City of Santa Fe, New Mexico

memo

2025-011229-HDRB, 815 Dunlap St., Westside-Guadalupe Historic District, contributing, Christopher Purvis, agent for Michael Zimmer, owner, proposes to replace and repair windows, remove the greenhouse, and stucco. An exception is requested to 14-5.2(D)(5)(a) for replacing historic windows.

Figure 3: Façade Map primaries highlighted in yellow.

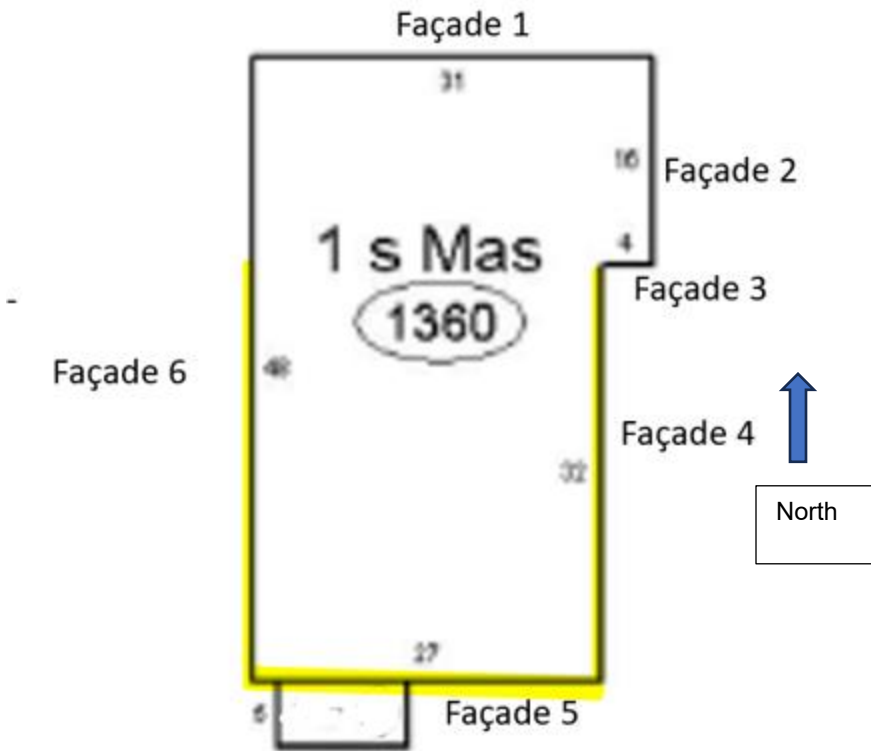
In case 2025-010291-HDRB, the property was reviewed status of the buildings. The Board designated the residential structure contributing and the east, west, and south elevations as primary, excluding the door opening and greenhouse on the south elevation, and excluding the non-historic materials. They also designated the storage structure and the garage units as non-contributing. The Board noted that if the greenhouse were to be removed, they would like the door behind it to be returned to a window.

Figure 4: Window Schedule

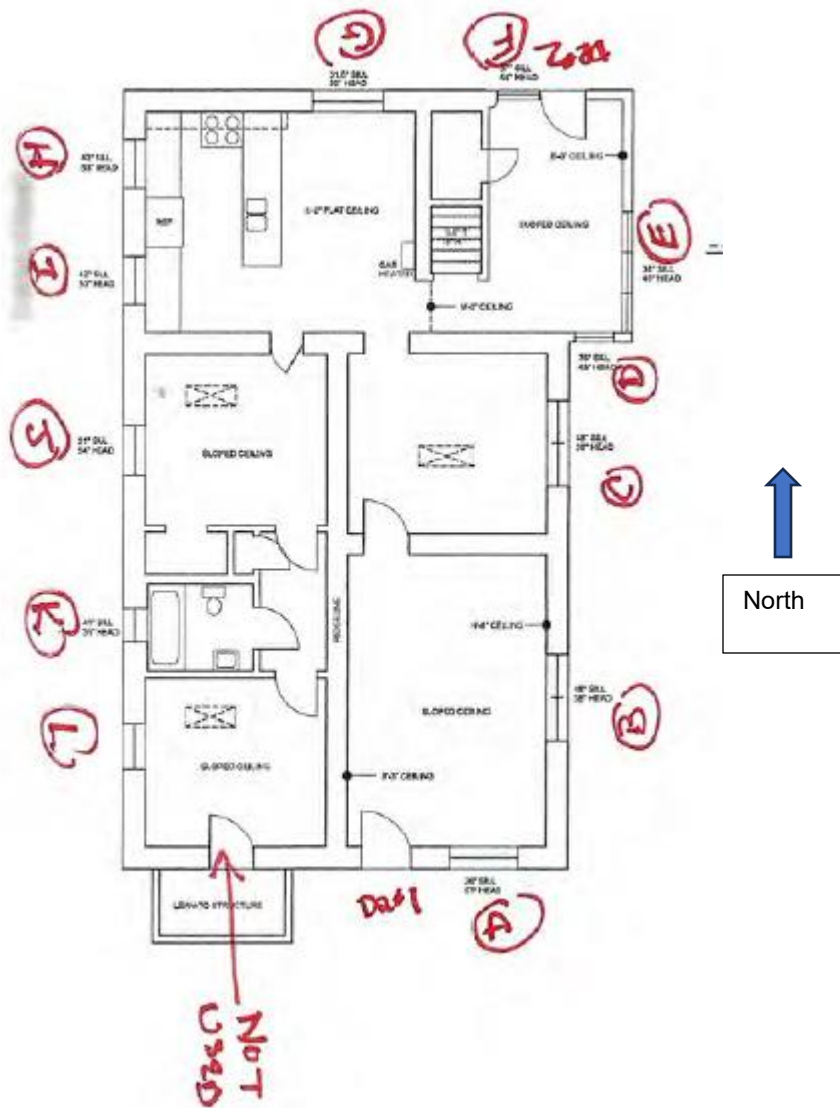
- 1) Replace windows and doors, including historic windows on the primary facades. The windows will be white K-Kron painted wood TDL insulated glass, with simulated divided lites in lite patterns to match the existing windows. An exception is requested to section 14-5.2(D)(5)(a) for replacing historic windows.
 - a. Window C is historic and restorable. The applicant proposes rehabilitating the window.
 - b. Windows G and K are non-historic and will be replaced.
 - c. Windows A, B, D, E, F, H, I, J, and L are historic but are beyond repair.

- 2) Remove the non-historic greenhouse structure on the primary façade
- 3) Reestablish the window on the left of the door of the south primary façade located behind the existing greenhouse, which is a non-historic door (located in Figure 4 as the door noted “not used”).
- 4) Stucco the residence using cementitious Buckskin.
- 5) Install ground-mounted HVAC.
- 6) Install a 48” high coyote fence on the north of the residence to screen the HVAC.

Exception to section 14-5.2(D)(5)(a): The applicant requests an exception to replace historic windows on a primary façade.

Staff finds that the exception criteria have been met and recommends approval of the exception to section 14-5.2(D)(5)(a) for replacing historic windows on primary facades and recommends approval of the other elements of the application as they comply with 14-5.2(D) General Design Standards for all Historic Districts, and 14-5.2(I) Westside-Guadalupe Historic District Design Standards.

Staff Response: Staff finds that this criterion is met. The lite patterns of the replacement windows are proposed to match those of the original windows. The residence will appear the same with the new windows as with the existing ones; therefore, the character of the district will not be harmed.

Staff Response: Staff finds that this criterion is met. The window assessment shows that all except one window is beyond repair. This would cause hardship for anyone to reside in the residence.

Staff Response: Staff finds that this criterion is met. Replacing inoperable windows will ensure that the residence can be occupied. All except one window shows in the assessment as not being operable.
